Village of Arlington Heights Public Works Department

Memorandum

To:	Sam Hubbard, Planning and Community Development
From:	Cris Papierniak, Assistant Director of Public Works 分
Date:	September 18, 2019
Subject:	2000 N Chestnut - Estates of LaSalle, P.C. #19-009 - Round 2

PLAN COMMISSION PC #19-009 SEP 1 3 2015 The Estates of LaSalle Subdivision PLANNING & COMMUNITY 2000 N Chestnut Ave DEVELOPMENT DEPARTMENT Preliminary & Final Plat of Subdivision Round 2

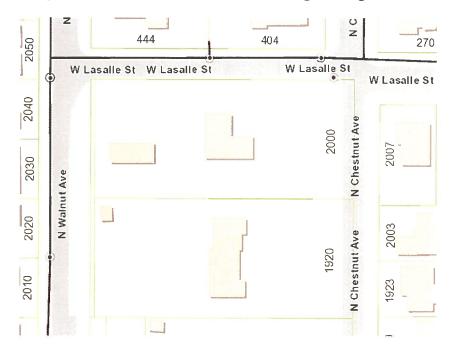
32. The utility pole/street light at the southwest corner of Chestnut Ave and La Salle that is to be relocated, the existing street light can be eliminated as there is an existing street light on the northwest corner. The Village may also require that a new street light be installed on Chestnut Ave, south of LaSalle St, near the south limits of the property, or include a fee in lieu of a new street light and the necessary electrical improvements. This can be addressed at permit. For reference, below are the existing street lights on LaSalle St:
